Docket Item #8  
DEVELOPMENT SPECIAL USE PERMIT #2004-0032  
COMMERCE BANK

Planning Commission Meeting  
November 1, 2005

**ISSUE:** Consideration of a request for a development special use permit, with site plan, for the construction of a free-standing bank building with a four lane drive- through facility.

**Pickett St Elevation - Bank and Drive Through**

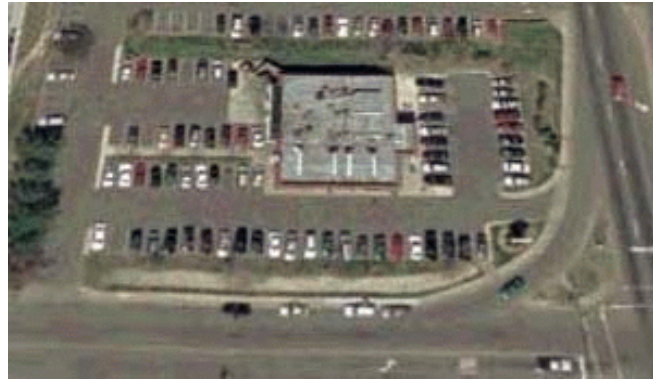
**Applicant Proposed Pickett St Building Elevation**

In addition, staff has proposed further refinements to the design as a condition of approval to occur prior to the release of the Final Site Plan. These proposed refinements will enhance and define the corner element, create a building base, break up the roofline, and add metal canopies to the entrances.

- a. The building shall be revised to incorporate the following:
    - i. A more prominent corner element.
    - ii. Precast or brick base.
    - iii. Vertical pilasters projecting above the roofline.

- iv. Prominent entry metal canopy for the corner and northern entrance.
  - b. The facade materials of the entire building and the drive-thru structure, shall be masonry (brick, precast, stone) or metal, including lintels and sills.

**Site Plan of Proposed Commerce Bank**

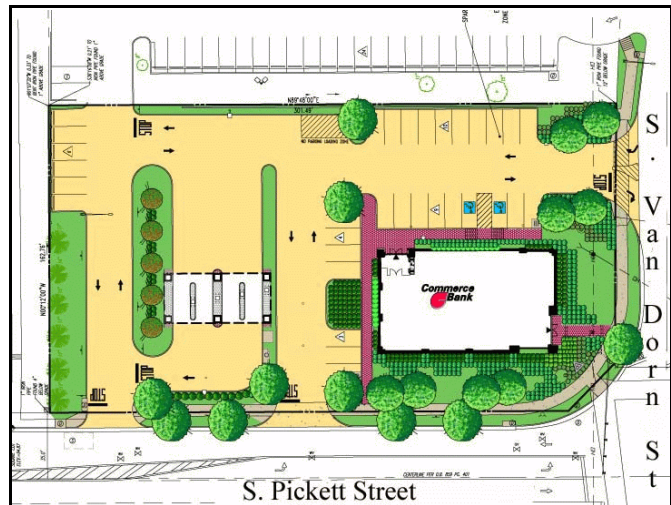
Staff has worked extensively with the applicant to make changes to the original proposed design, and successfully effected the following changes:

- ▶ The applicant agreed to move the building from the center of the site to the southeast corner of the parcel, bringing the building mass and presence closer to and aligned with the street. Parking, originally designed to surround the building, has been relocated to the rear and north side of the building away from the streetscape and pedestrian experience along the streets. Despite efforts to do so, the building could not be moved any closer to the South Pickett Street frontage due to the presence of a recorded setback covenant that was imposed as part of the original subdivision.

- ▶ The primary building entrance was moved to South Van Dorn Street close to the street corner so the building is orientated to the public right-of-way.

- ▶ The original overall building design, more suited to a suburban location than to the City of Alexandria urban building forms has been changed. Materials will now include masonry, pre-cast, and metal panels along with an appropriate level of window glazing.

- ▶ The building design now includes high quality materials, such as masonry and precast elements, in addition to a balance of glazing.
- ▶ Limits on signage to reflect materials and scale that is compatible with what would be appropriate for this area in the future are being imposed.

1. The design of the buildings shall be generally consistent with the preliminary building elevations dated August 31, 2005 and shall be revised to provide the following to the satisfaction of the Director of Planning and Zoning:
